PETITIONER'S APPLICATION - ARLINGTON HEIGHTS PLAN COMMISSION

Petition #: P.C. 15-020
 Petitioner: Jeffrey Funke
515 Lincoln Avenue
Winnetka, IL 60093
 Owner: Arlington Downs WPH, LLC;
Arlington Downs Commercial, LLC;
Arlington Downs Commercial, LLC;
 Contact Person: Vince Bertucci
 Address: 515 Lincoln Avenue
Winnetka, IL 60093
 Phone #: 312.451.5103
 Fax #: N/A
 E-Mail: vbortucci@chiarc.net

PLAN COMMISSION PC #15-020
Arlington Downs Phase 3
3400 W. Euclid Ave.
PUD Amendment
Round 1

PLAN COMMISSION
RESPONSE TO REVIEW COMMENTS
Arlington Downs Retail Development
10.07.15 *(Revised 10.22.15)*

FIRE ENGINE TURNING TEMPLATE

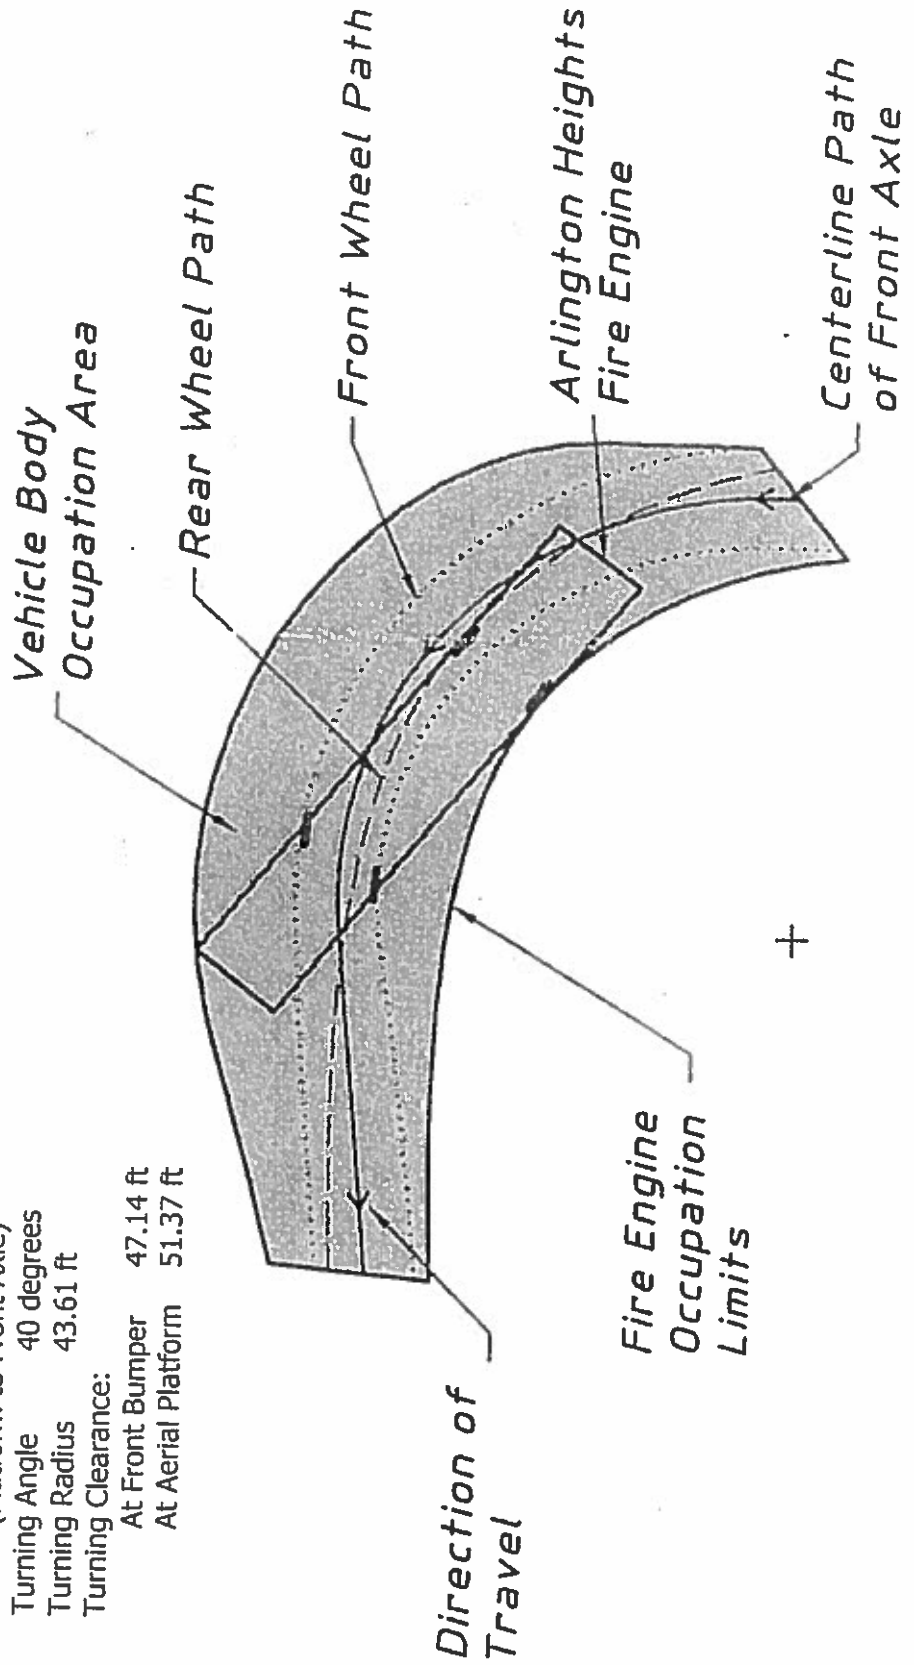
15. Provide an exhibit to engineering scale showing the turning path of the Fire Department's responding vehicle, in this case the tower truck. Exhibit must show front and rear wheel paths and the extent of the front and rear overhangs, as provided in an "Autoturn" exhibit. The vehicle shall be shown maneuvering through the site in all possible directions of travel. Attached are the specifications for the tower apparatus.
